**Halton District School Board  
RFT 25-061 School Renovation Project - Paul A Fisher PS**

**Addendum No. 2**

PROJECT NO. 24131  
HOSSACK ARCHITECTURE

**ADDENDUM NO. 2**

Paul A. Fisher  
Type A1

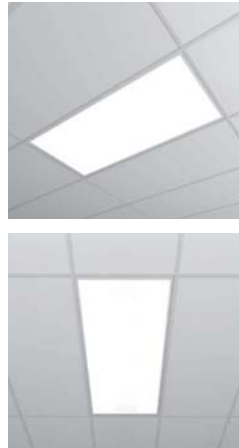
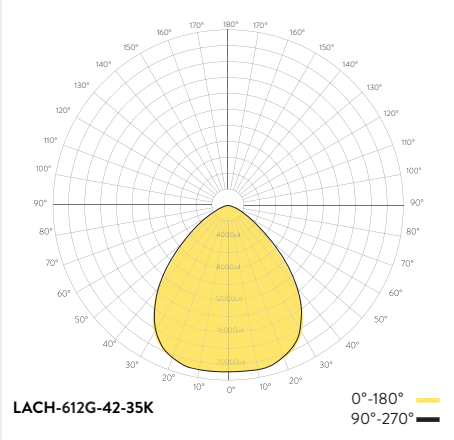
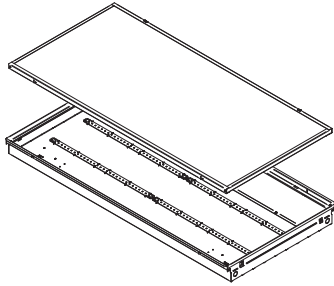
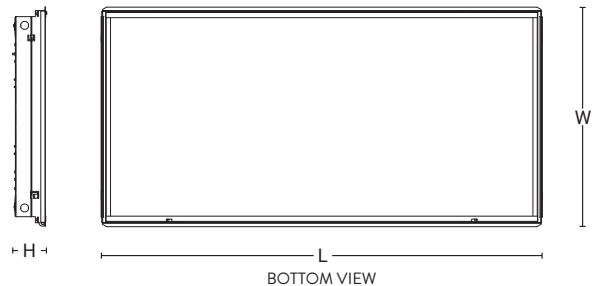
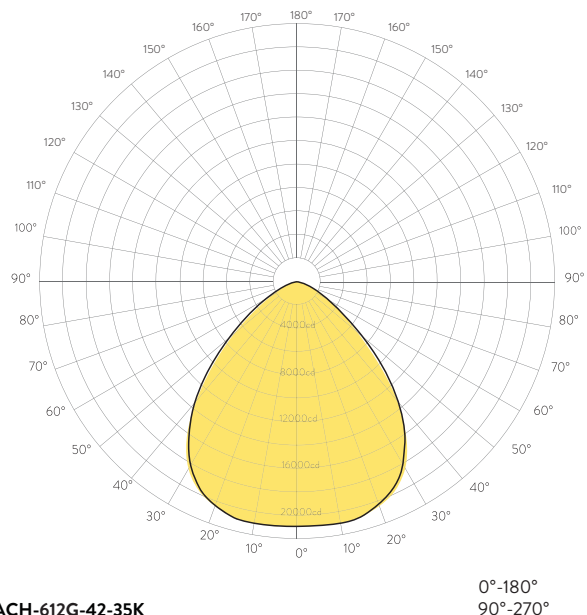
- QUESTION 4: Type A1 and B1 are existing fixtures and are being removed, stored and re-installed. Can we be provided with the specification for the existing fixtures to know if they are LED? Do all fixtures that are being reinstalled need to be re-lamped? Do all fixtures that are being reinstalled need to be cleaned?

- ANSWER 4: (HAA Response) Cut Sheets of the existing fixtures are attached. The existing fixtures are LED. Light Fixtures to be re-installed must be cleaned & tested to ensure they are in working condition prior to re-installation per contract. Relamping is not part of the base bid but any lights damaged during removal/storage/reinstallation will need to be repaired and/or replaced as needed, as part of the contract price
